## Planning and Zoning Board

**CASE NUMBER:** Z17-00384  
**LOCATION/ADDRESS:** The 2800 to 2900 block of South Signal Butte Road (west side) and the 10600 to 10800 block of East Guadalupe Road (south side)  
**GENERAL VICINITY:** Located on the south side of Guadalupe Road and the west side of Signal Butte Road.  
**REQUEST:** Rezone from AG to LC; and Site Plan Review.  
**PURPOSE:** This request will allow the development of a group commercial center.  
**COUNCIL DISTRICT:** District 6  
**OWNER:** Walgreen Arizona Drug Co.  
**APPLICANT:** Dennis Newcombe, Beus Gilbert PLLC and Cain Garcia, RKAA Architects Inc.  
**STAFF PLANNER:** Wahid Alam, AICP-Planner II

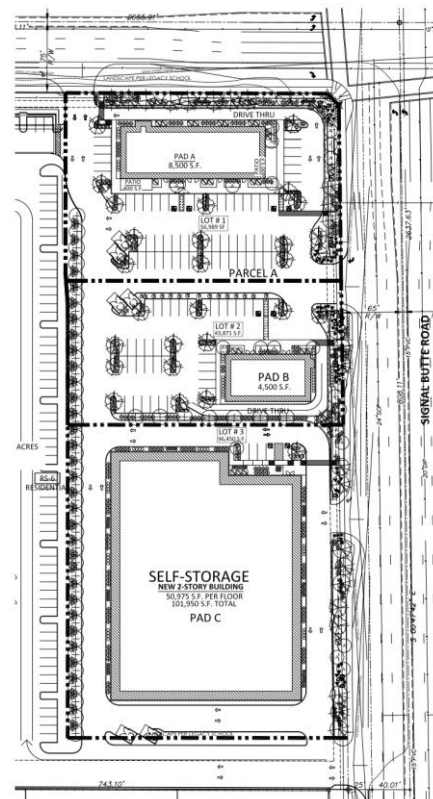
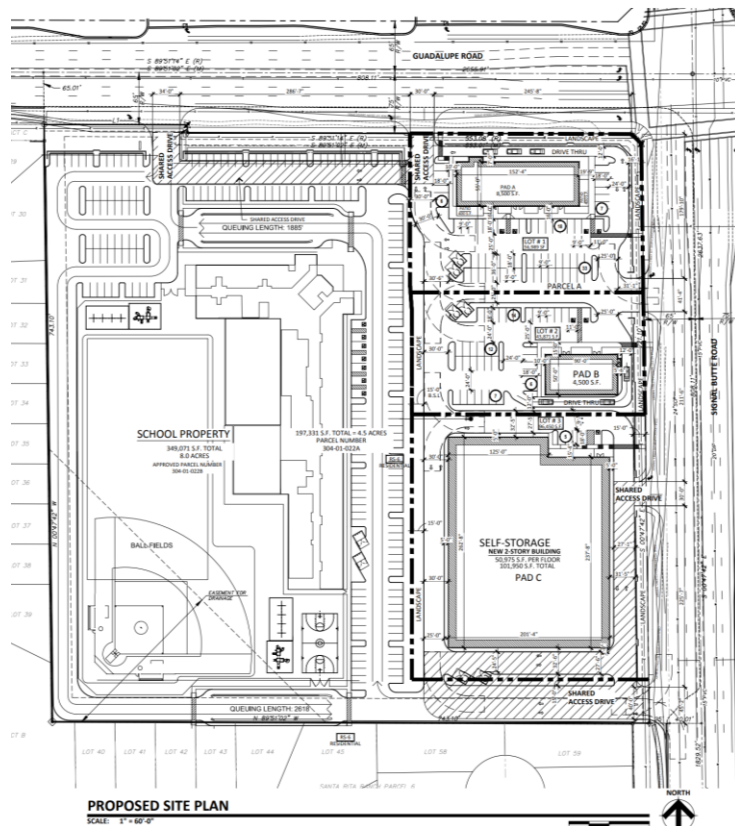
The proposed site plan shows three lots next to each other. The proposed development is not organized or grouped as a cohesive, visually integrated, commercial development. The proposal is laid out for three buildings on three pad sites with no design organization except shared vehicular access at some points. This has been a fairly typical type of layout for properties like this. A goal of the General Plan is change this pattern of building and to build sites like this in a way that increases connectivity, walkability, sense of place, and neighborhood. The proposed uses need better organization of the site plan for a group commercial. The three buildings should belong to one another not just next to each other.

The proposed development needs to organize all the land uses as one development in site plan/layout, building design and landscaping. In addition, a design/development theme will tie or bind all the uses proposed so that when the development is built in phases there will be integration and it will look like a single development. The applicant has agreed to revise the site plan in a manner to bring the buildings on pad sites A and B closer together to frame the northern driveway from Signal Butte (Condition #5a

The Site Plan and Landscape Plan for the mini-storage are not the same. According to elevations there are roll-up doors along west and south elevations, but the Landscape Plan shows plant materials along these sides of the building. In discussion with the applicant staff has been told the elevations are correct, there will not be landscaping in these areas. An alternate paving material is needed next to the building on the south and west sides to distinguish the drive aisle from the loading areas next to the building. (Condition #5d).

With the current site plan, there are potential conflicts with circulation around pad site A. One concern is the traffic stacking for the drive-thru and the vehicles backing from parking stalls along the east elevation of the building in pad site A. The shared driveway access from Guadalupe Road has the potential conflict with drive-thru exit traffic due to very little depth/throat for traffic exiting the drive-thru. These issues should be resolved with the relocation of the building to the south as described above. The redesign will need to have a throat depth for the driveway from the Guadalupe Road ROW that meets or exceeds that for the access to the school to the west. (Condition #5e).

There is no internal pedestrian connectivity between the three buildings. Also, there is no pedestrian connectivity shown along the shared access driveway from Signal Butte Road. Show the pedestrian connectivity between the school and the Signal Butte Road. Provide internal pedestrian connectivity with refuse area between the proposed three buildings (Condition #5f and 5g).

- a) **Relocate the building on PAD A to the south so it frames the north side of the driveway access located between Lot 1 and Lot 2.**
  - b) **Relocate the building on Pad B to the north so it frames the south side of the driveway access located between Lot 1 and Lot 2.**

- c) **Compliance with foundation base requirements from Sec. 11-33-5 of the Mesa Zoning Ordinance.**
  - d) **Stamped asphalt or similar material on 5' of the paved surface located next to the rollup doors on the west and south sides of the self-storage building. The surface material must be distinctly different from the 25' wide driving surface. The total width of the paved surface is 30'.**

- e) **A throat depth, for the shared access drive along Guadalupe Road, that meets or exceeds the throat depth for the access drive to the school located to the west.**

- f) **An internal pedestrian connection between PAD A and PAD B and between PAD B and Pad C.**
  - g) **A 6' wide pedestrian connection from Signal Butte Road to the school to the west. The pedestrian connection to be located along the shared access drive that is south of PAD C.**
